City of West Linn
PRE-APPLICATION CONFERENCE MEETING
February 21, 2013

SUBJECT: 7 lot subdivision at 1475, 1485 and 1495 Rosemont Road.

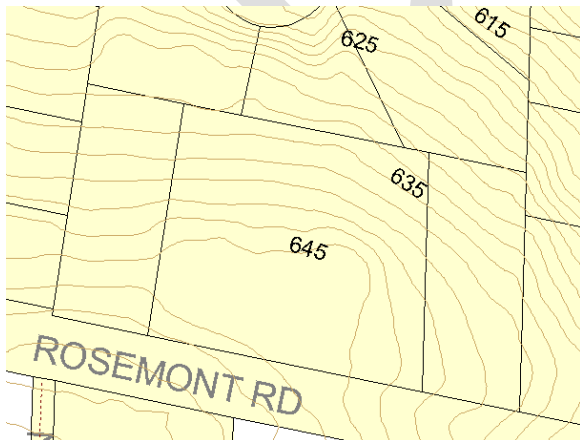
The site topography slopes from Rosemont Road downhill to the rear of the lot. There is a 16 foot drop in elevation from front to rear. There are no natural hazards or environmental constraints (wetlands etc.) noted on this property. The rear or north half of the lot is a grass field.

There are number of mature trees on the site; especially around the house and in the upper portion of the site (see photos below).

The applicant will need to prepare a tree survey of the property, indicating location, size, and species of each tree on the site. Each tree needs to be tagged in the field with a number that corresponds to the tree inventory map. The City Arborist will then determine which trees are significant. CDC Section 55.100(B) (2) requires that up to 20% of the site shall be set aside to protect the “dripline plus 10 feet” of significant trees. This requirement is expected to have a significant impact on this application in terms of the number of lots allowed, the configuration of the lots and/or the available building envelopes.

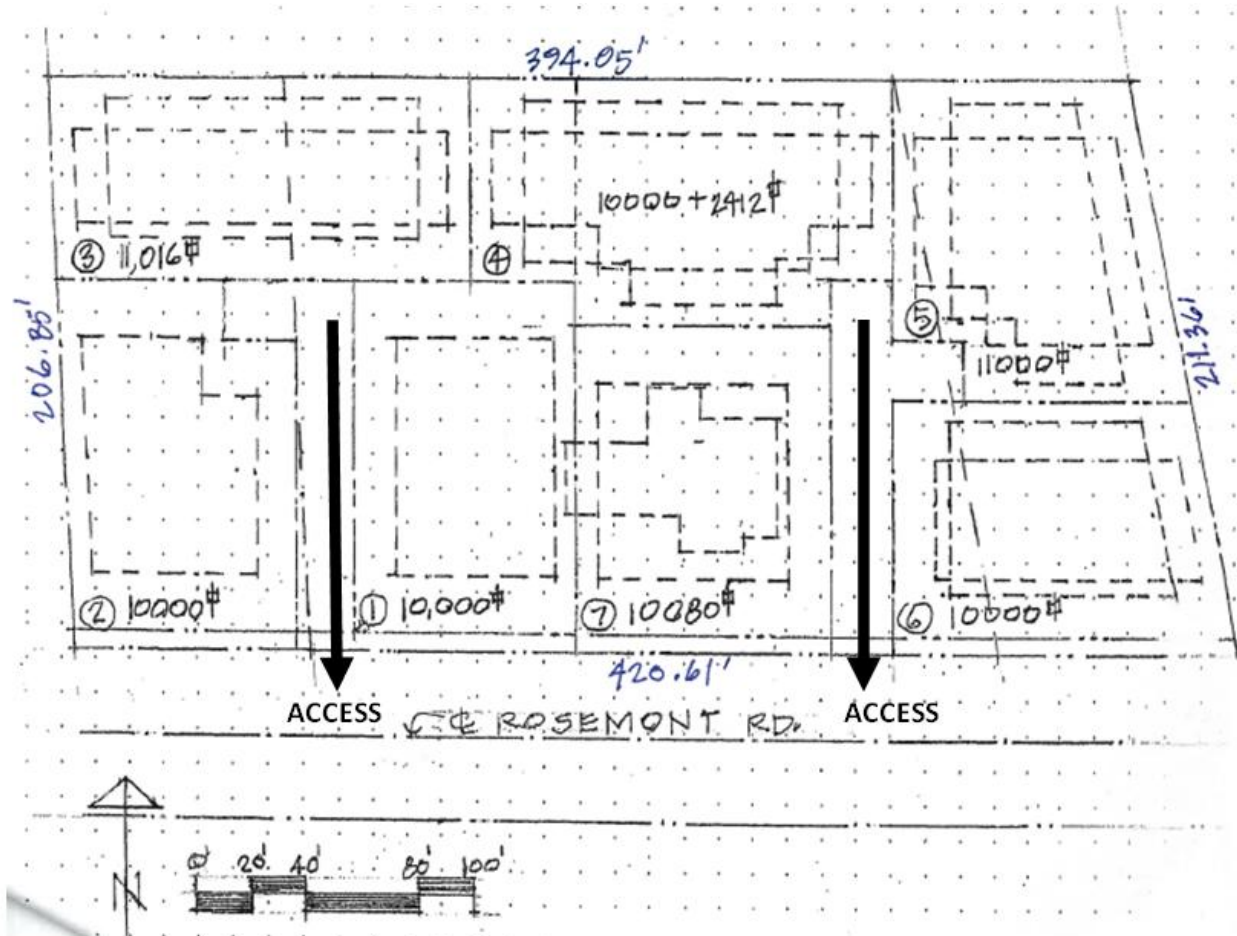
After ROW dedication along Rosemont Road and assuming all lots meet the minimum lot size and dimensional standards of the R-10 zone, the proposed arrangement of lots is four lots across the Rosemont Road frontage and three lots in the rear (see drawing below). The rear lots may be accessed by access easements or flag lot stems. Flag lot stems are connected to and owned fee simple by the lot that they serve. The square footage in the flag lot stem cannot count to the square footage of the flag lot. Meanwhile, the square footage of access easements or mutual access easement has to be deducted from the square footage of the lots that they traverse. There are no setbacks as measured from access easements but setbacks do apply to flag lot stems. Staff can support either access option.

Prior to recording the subdivision plat, the existing house (lot 7 below) must be either demolished or the lot will have to be designed around the house with the appropriate setbacks and lot size.

If the applicant wants to retain the existing driveway to serve only the existing house on lot 7 the two additional driveways serving the other lots would require a Class II Variance from the access separation standards.
